Category S	Repair Guidance	Ref. No. R044/12A	Page 1 of 8
Coverage <input type="checkbox"/> Distributor only <input checked="" type="checkbox"/> Please inform your dealers		Date Issued June 18, 2012	
Please convey this information to your <input type="checkbox"/> Director <input checked="" type="checkbox"/> General Manager <input checked="" type="checkbox"/> Warranty Dept. <input checked="" type="checkbox"/> Parts Dept. <input checked="" type="checkbox"/> Training Dept. <input checked="" type="checkbox"/> Field Rep.		Date Revised June 13, 2014	
Applicable Model CX-5 (KE)		Applicable Countries or Specifications Worldwide

Revision Note: Following the implementation of further mass-production change, the related information has been revised.

Subject: Liftgate Opener Switch Not Operate

Illustration

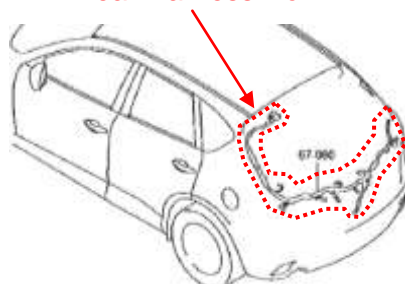
Use of the water-proof sheet has been discontinued; instead a water-proof protector has been installed to protect the opener switch.

NOTE: For the additional installation of water-proof protector, the shape of the rear harness No. 2 has also been changed. This change was implemented prior to installation of the water-proof protector.

NOTE: Preceding to the implementation of water-proof protector, the shape of the rear harness No.2 was changed.
